SUMMARY OF PUBLIC CONCERNS: LOWER GLADE AND UPPER MCPHEE- CUTTING PERMIT 66

March 29, 2017: Response supporting Lower Glade and Upper McPhee – cutting permit 66.

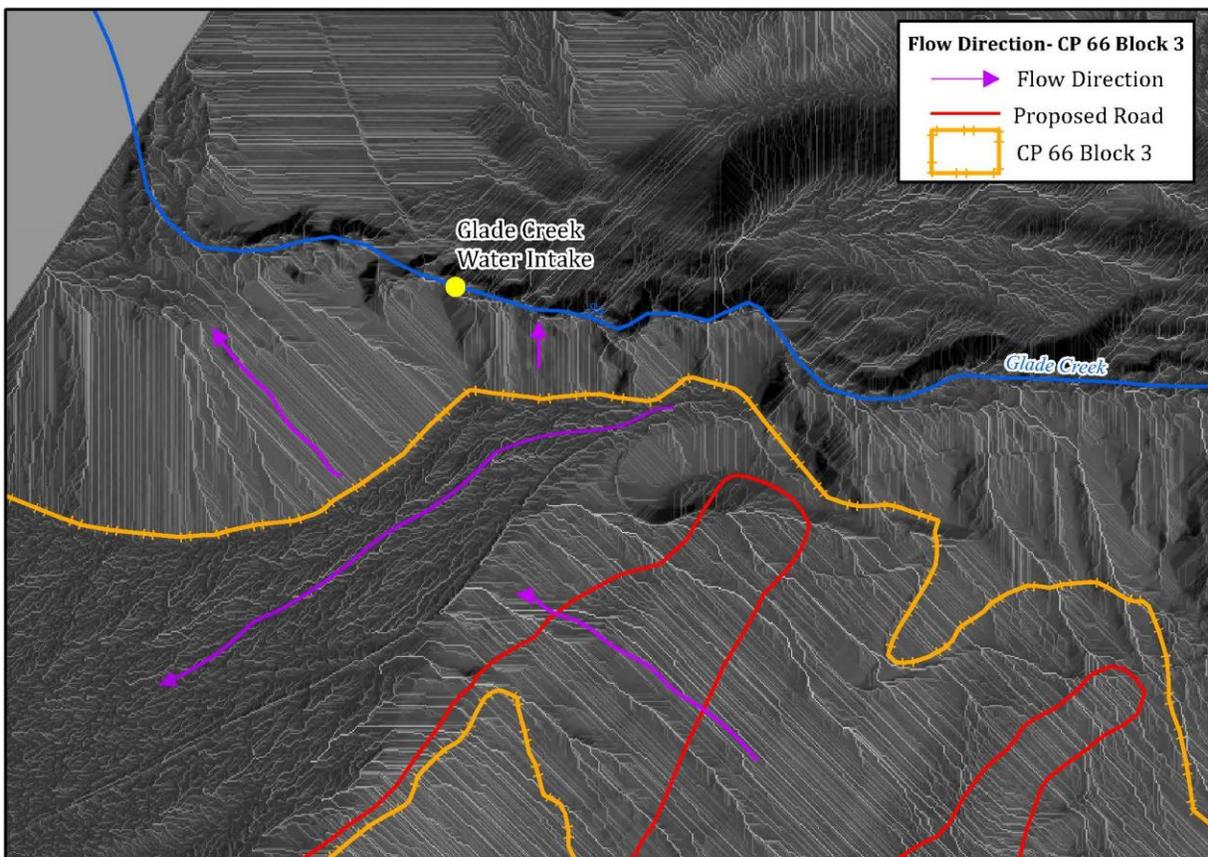
6) *“Request to exceed legislated buffer distances from creeks and small streams.”*

Typically Kalesnikoff will not exceed legislated buffer distances from creeks or small streams unless there are circumstances that warrant such a management strategy. The logging currently proposed meets the legislated buffer distances from all creeks and small streams. The closest

logging gets to Glade Creek is on the boundary of 66-3. This boundary is appropriately located on the slope break above Glade Creek as it follows the top of the inner gorge. The boundary is outside of the riparian management zone and in this case exceeds the legislated buffer distance. Halleran assessed this boundary as to whether a flat over step assessment should be completed⁸. Halleran found the slope within the block drains away from this boundary (slope break) and the drainage plan for the proposed road will follow natural drainage, therefore a flat over steep assessment was not required.
